**LAKE GEORGE PARK COMMISSION  
PROJECT SYNOPSIS**

Meeting Date January 22, 2019

<b>Applicant</b> Congers Point Association	<b>Facility</b> Congers Point Association	<b>Parcel</b> 171.15-3-80 Bolton
<b>Application #</b> 5220-71-18 DM MINOR	<b>Lakefront</b> 190 feet 2 straight, T, L, U, F or 1 E docks & 2 moorings	<b>Location</b> Congers Point N Congers Point
<b>Date Received</b> 09/26/2018	<b>SEQR type</b> Type II, not subject to SEQRA	<b>Comment period ends</b> 02/22/2019

**Project**  
Reconfigure an existing wharf complex and change from stake to pile supported wharfs in accordance with plans attached. A variance is required.

**PROPOSED LAYOUT V2**

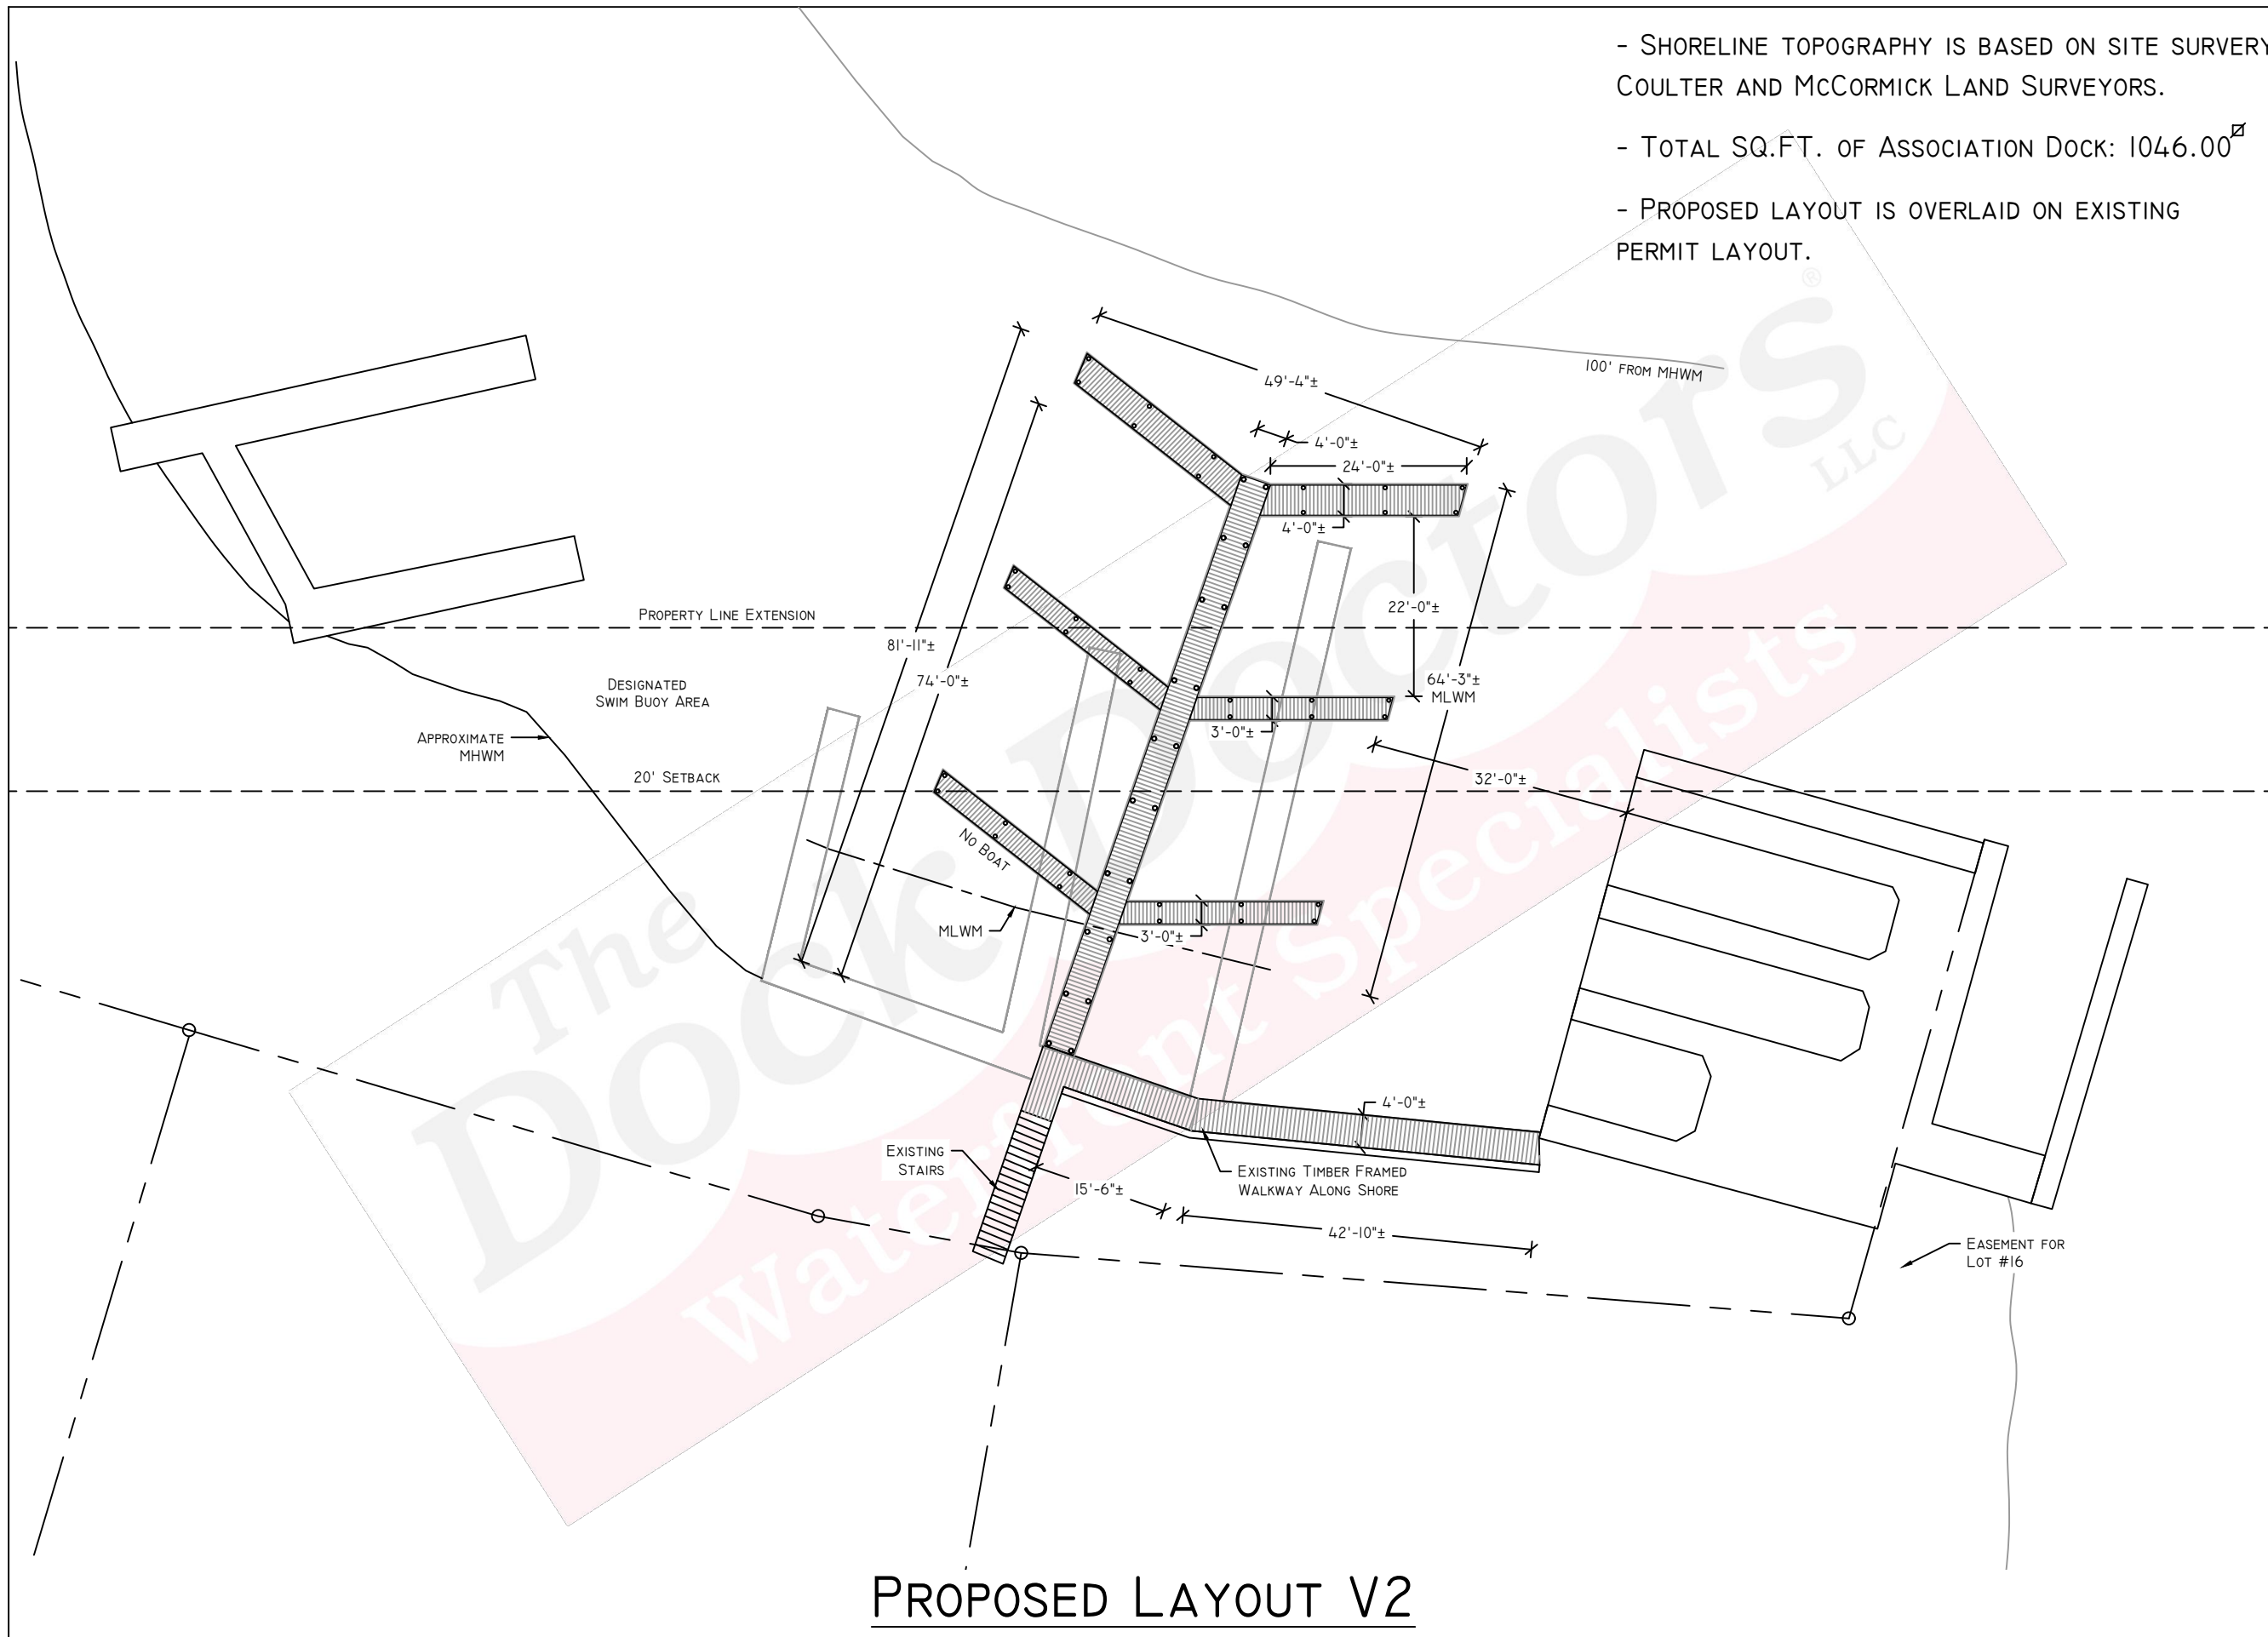
1. number of docks (7 v 2)
2. width (105.9 v 80)
3. square footage (2300 v 1400)
4. 20' setback (48' beyond, 27' over PL), (550.5 sq ft)
5. Off-shore distance (24'3" beyond limit)

The preferred proposal will increase the number of docks and length and square footage beyond the off-shore limit, 20' setback and property line and the total square footage. A 12<sup>th</sup> slip would be created, although it is not proposed to be used. It will decrease the width of docks along the shoreline.

- Proposed Layout V2 - Preferred
  - Revised per the commissioners comments
  - Brings all association boats into one central location on the property
  - Creates a larger beach area for the association members
  - Creates a more safe beach area for the association members by moving the boats further away
  - Creates more equitable slips
  - Creates easier egress and ingress of boats
  - Maintains a safe fairway between the dock and boathouse
  - Based on the current water depths at the site, It is our professional recommendation that the dock as shown is as short as it should be designed
